Access Compliance Report

Public Rights-of-Way

Intersection ID: N/A	Main Street: REGAL_OAKS_DR	Cross Street: WINDUNG_CEDAR_TR	Location: SE
ADA ID: 2AD48B200412	Ramp Type: PerpDiag	Initial Pass/Fail: Fail	Overall Compliance: No
Codes/Mitigation Info/Possible Solution		Field Measurements/Component Compliance

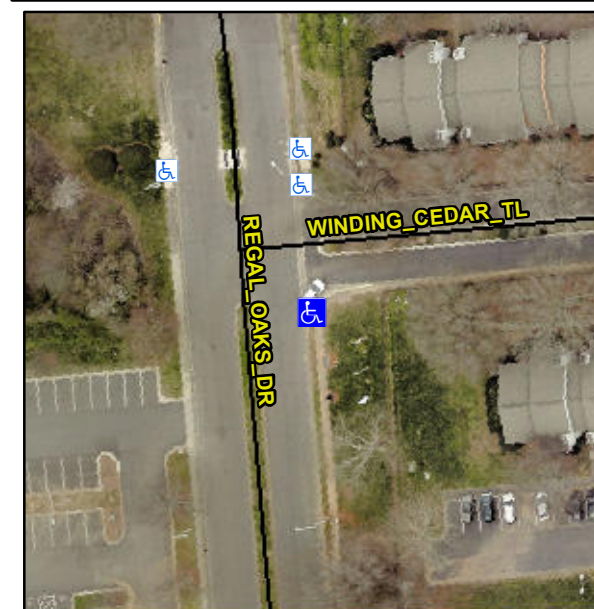
Not Found, R304.2.2

Compliance	Description	Data	Compliance	Description	Data
N/A	Ramp Length (in)	48.0	No	Ramp Slope (%)	12.0
Yes	Ramp Width (in)	54.0	Yes	Ramp XSlope (%)	2.1
N/A	Flare Type LT	N/A	N/A	Flare Type RT	N/A
N/A	Flare Slope LT (%)	N/A	N/A	Flare Slope RT (%)	N/A
N/A	Flare Traversable LT?	N/A	N/A	Flare Traversable RT?	N/A
N/A	Landing Length (in)	N/A	N/A	DWS Provided?	N/A
N/A	Landing Width (in)	N/A	N/A	DWS Contrast?	N/A
N/A	Landing Slope (%)	N/A	N/A	DWS Length (in)	N/A
N/A	Landing X Slope (%)	N/A	N/A	DWS Full Width?	N/A
N/A	Landing Curb? (Y/N)	N/A	N/A	DWS Offset (in)	N/A
N/A	Shared Landing?	N/A			
N/A	Gutter Ponding?	N/A	N/A	Gutter Slope (%)	N/A
N/A	Gutter Lip Ht (in)	N/A	N/A	Gutter X Slope (%)	N/A
N/A	Painted X Walk1?	No	N/A	Painted X Walk2?	No
	X Walk 1 Direction	To N		X Walk 2 Direction	To W
N/A	X Walk 1 Width (in)	N/A	N/A	X Walk 2 Width (in)	N/A
	X Walk 1 Slope (%)	0.2		X Walk 2 Slope (%)	1.0
	X Walk 1 X Slope (%)	7.5		X Walk 2 X Slope (%)	1.6

Remove & Replace Curb Ramp With Two New Directional Ramps or Equivalent.
